269D™ HELICOPTER

ASB DB-070

SUBJECT: POWER TRAIN SYSTEM – KAflex® Driveshaft – One-Time Inspection of KAflex® Assemblies for Axial Play and Installation of Bolt (NAS6605-25)

KAFLEX INSTALLATION BOLT AND MALE SPLINES
FIGURE 1

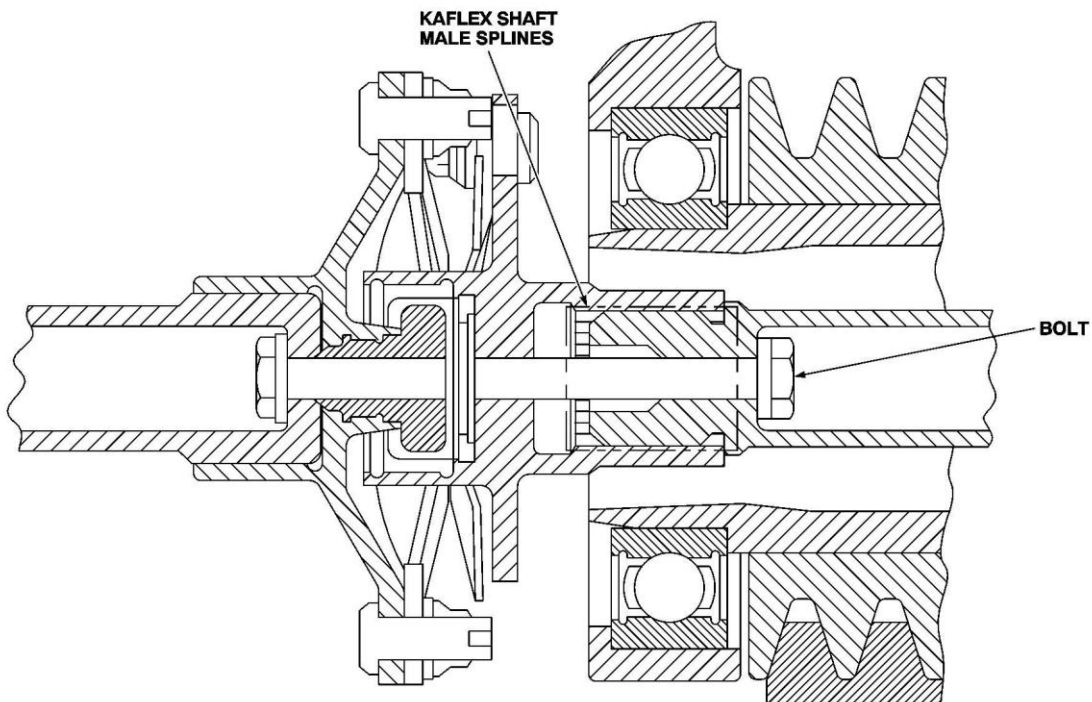
- (b) Remove bolt, washer, and lockwasher and push the forward (engine side) KAflex assembly toward engine.
1. Using an inspection mirror (commercially available or equivalent) and bright, white, non-LED flashlight (commercially available or equivalent), inspect KAflex shaft male splines for wear, discoloration, and debris particles. (Refer to Figure 1).

- a If spline wear, discoloration, and/or debris particles are present, remove forward and aft KAflex assemblies and inspect splines. (Refer to HMI CSP-D-2, Section 10, Paragraph 10-57 or HMI CSP-D-9, Section 10, Paragraph 10-57).

- b If no spline wear, discoloration, and/or debris particles are present, clean and apply grease (MIL-PRF-81322 or equivalent) and push the forward (engine side) KAflex assembly aft, using hand force, for full engagement with aft KAflex shaft splines.

- (2) Apply light coat of sealing compound (CA 1000 or equivalent) around shank of bolt (NAS6605-25).
- NOTE:
- Lockwasher (AN936A516) is replaced anytime bolt is loosened.

- (3) Install bolt (NAS6605-25), washer (AN960C516 or NAS1149C0563R), and lockwasher (AN936A516).
 - (4) Torque bolt (NAS6605-25) to 100 – 140 inch-pounds.
